SAJ-2004-12518 (SP-JCM) St. John Marina Yacht Club Rebuttal Response

Appendix C.5 - Response To Comments Raised By The United States Environmental Protection Agency August 15, 2017
Page 5

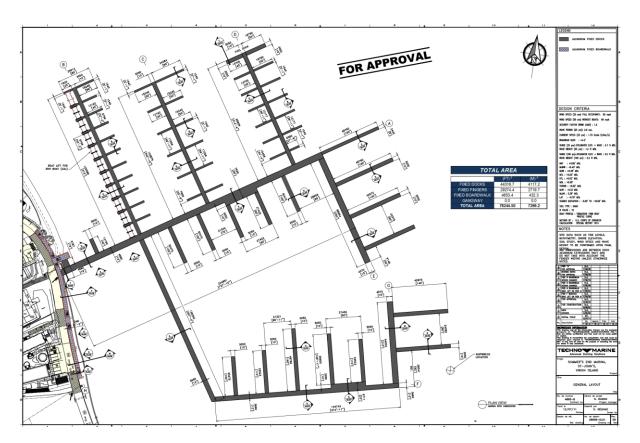
EPA has expressed concerns regarding the scope of benthic habitat impacts based on the size of the project. Since EPA provided comments, modifications to the project design have resulted in the following reductions to impacts to benthic resources as follows:

- The dock permitted by CZM is 1.7 acres or 74,052 sq.ft., the new layout is 73,591.10 sq.ft., a reduction of 460.9 sq.ft. This has been accomplished through the narrowing of piers and removal of a finger pier.

- The previous marina design directly impacted approximately 2,500 ft² of seagrass due to the placement of approximately 1,333 piles ranging from 12-17" in diameters. Due to wave turbulence, seagrass will also be lost surrounding the piles. The previous dock design occupied 1.7 acres, of which 181 ft² will be over areas colonized with seagrass and coral rubble, 1,567 ft² will be located over area of sparse seagrass, 41,546.37 ft² will be located over areas with 30%-100% seagrass coverage, 27,072 ft² will be located over areas with 5-30% seagrass and algae coverage and 4,717 ft² will be located over areas with 5% seagrass/algae coverage. The dock would have resulted in a shading impact of 1.42 acres and with the use of the graded decking we assumed an approximate 46% survival rate based on NMFS studies, or stated differently, a 0.85 acre sea turtle foraging habitat loss due to shading. (Landry, 2008).

- The proposed slip count is now 144 and the dock design has been modified to reduce these impacts. The number of pilings has been reduced to 960, reducing the piling footprints to 1350 sq.ft. (there will still be additional seagrass loss due to wave turbulence). The revised dock square footage is 73,591.1sq. ft or 1.69 acres (dock less on shore boardwalk). Of this 66,021.8 sq. ft., or 1.51 acres has SAV. With a 46% survival rate, there will be a 0.81 acre loss of sea turtle foraging habitat loss due to shading.

Previous	Current	Reduction
Dock Size	74052sf	73591.1sf	460.9sf
Slips	145	144	1
Pilings	1333	960	376
Direct Impact	2500sf	1350sf	1150sf
Shading	0.85acres	0.81acre	0.04acres
